# **STATEMENT OF OBJECTION TO TRANSPORT ASSESSMENT**

**PREPARED FOR  
SAVE COFFERIDGE CLOSE  
BY**

**JOHN HILTON**

## LONDON ROAD/HORSEFAIR GREEN JUNCTION PROPOSED KERB REALIGNMENT (2140/SK/59 Rev B)

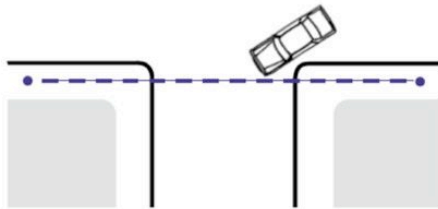
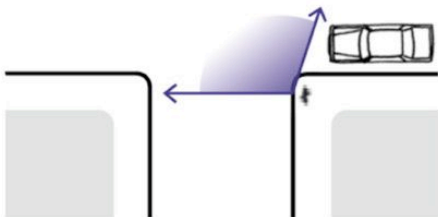
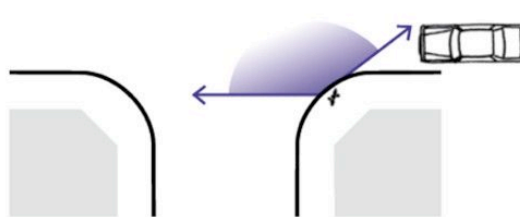
- 9.3.4 The diagram on the opposite page, reproducing the relevant part of 2140/SK/59 Rev B and of Figure 6.3 of the Manual for Streets, demonstrates that:
